Work Order ID 146555

Item Name: Replacement Std Skidtube

DART SERVICE INSTRUCTION

TO AMEND INSTALLATION INSTRUCTIONS IIN-D117-762 REV. D AND
INSTRUCTIONS FOR CONTINUED AIRWORTHINESS ICA-D117-762 REV. 3

FIGURE 1 - GHU UPGRADE INSTALLATION

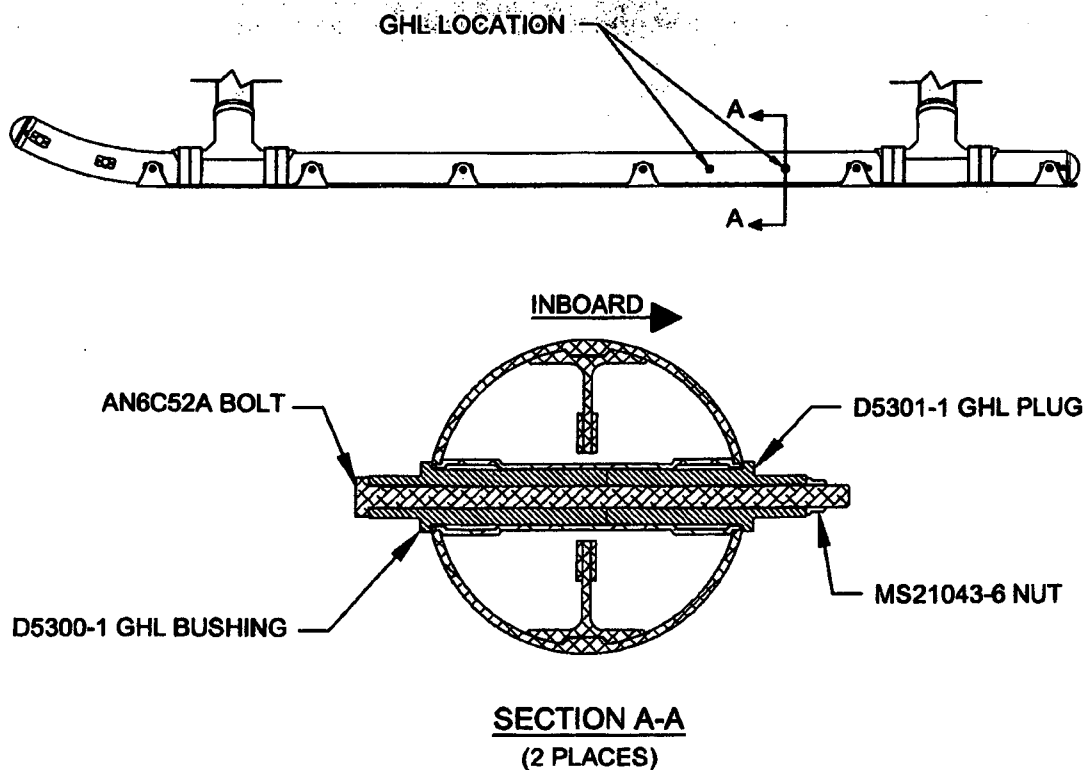
The purpose of this Dart Service Instruction (DSI) is to replace the ground handling lugs (D3864-1 Bushings, AN6C51A Bolts and MS21043-6 Nuts) on the D145-762-XXX Skidtubes with a structurally superior lug design. This service instruction only affects D145-762-043/-013/-113 Skidtubes at change 004 or earlier and D145-762-045/-015/-115 Skidtubes at change 001. It is highly recommended to install DSI 9731-011 GHL Upgrade Kit in order to prevent early structural failure of the D145-762-XXX Skidtubes. Each DSI 9731-011 GHL Upgrade Kit provides the necessary parts and hardware for installation on one skidtube.

- 2.1 Remove (qty 4) D3864-1 Bushings per Skidtube by removing (qty 2) AN6C51A Bolts and (qty 2) MS21043-6 Nuts
- 2.2 Loosely install (qty 2) D5300-1 GHL Bushing & (qty 2) D5301-1 GHL Plug wet with Proseal 890 or MIL-S-8802 Class B2 Sealant in location shown in Figure 1.
- 2.3 Install AN6C52A Bolts and (qty 2) MS21043-6 Nuts in accordance with Figure 1. Clean up squeezed out Proseal and apply fillet seal around D5300-1 & D5301-1.
- 2.4 Torque AN6C52A Bolts 160 - 190 In-lbs (18.1 - 21.5 N-m).
